# UNITED STATES PATENT AND TRADEMARK OFFICE

**Office Action Summary**

3. Claims rejected under 35 U.S.C. 102(b) as being anticipated by Gumb [US 5,172,805].

Title: BUTTON STRUCTURE AND DESIGN METHOD FOR LATCHING PREVENTION

Gumb discloses a pushbutton for electronic device [Figure 2] comprising:

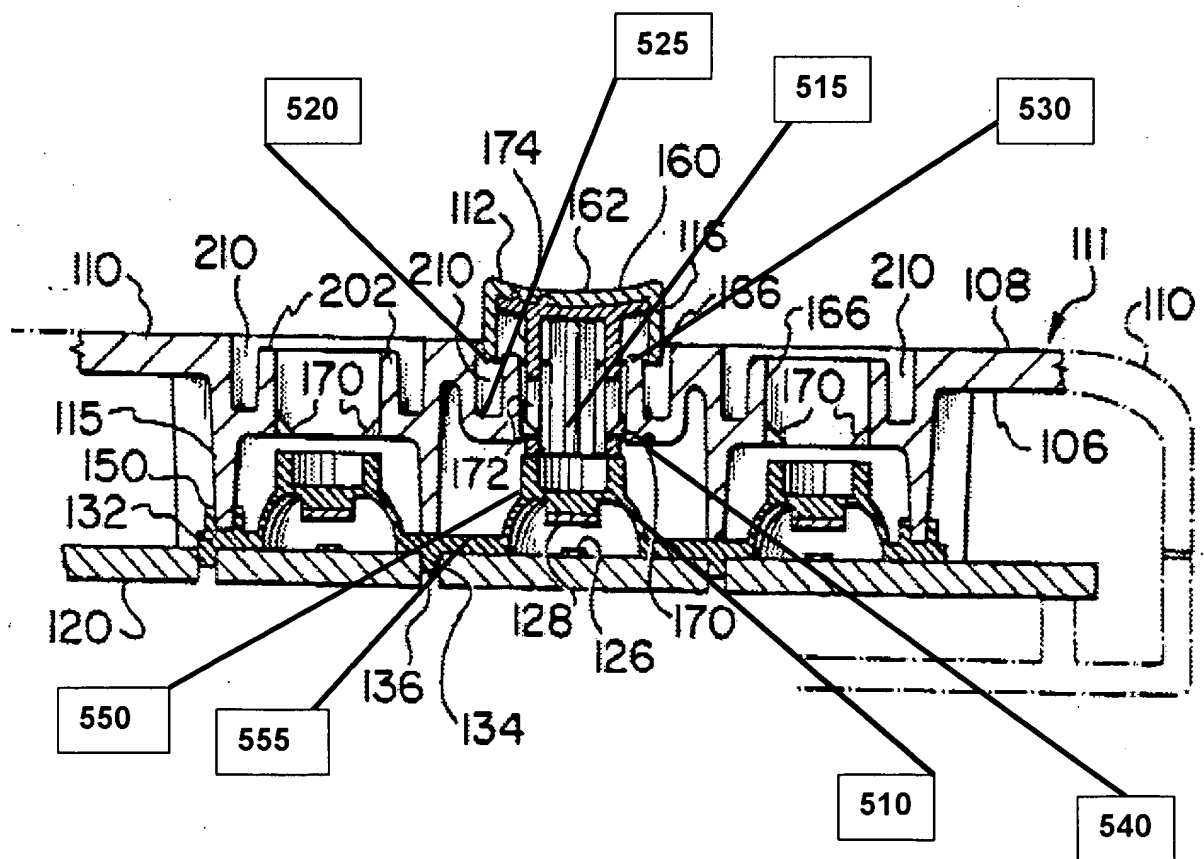
- a housing [110];
- a button cover [160];
- a circuit board [120];
- a button body [112], a wing plate [510], a positioning plate [part of 132; Figure 2]; a contact rod [515].

Gumb discloses all the limitations of claimed invention including the dimensional relationship satisfying the equations:

$E - B > D$ ;  $E - D > A$ ;  $D > A$ ;  $A \geq C$ ;  $A \geq B$  and  $C \geq B$ , where:

- the dimension B is height from the bottom of the contact rod

to the contact point on the circuit board [distance between 128 and 126];

- dimension C is height from the bottom of the button body to the outer surface of the housing [distance between 520-525];
- the dimension A [distance between 550 and 555] is height of the wing plate;
- the dimension D is height of the sidewall of button cover next to the button body [dimension between 230 and 240],
- the dimension E is height from the top of the button body [top of 112] to top end [550] of the wing plate.

Regarding Claim 7, the positioning plate, the wing plate and contact rod assembled in a single unit (integrative unit). Regarding Claim 8, the contact rod and button body are separately made. Regarding Claim 9, the wing plate disclosed is elastic.
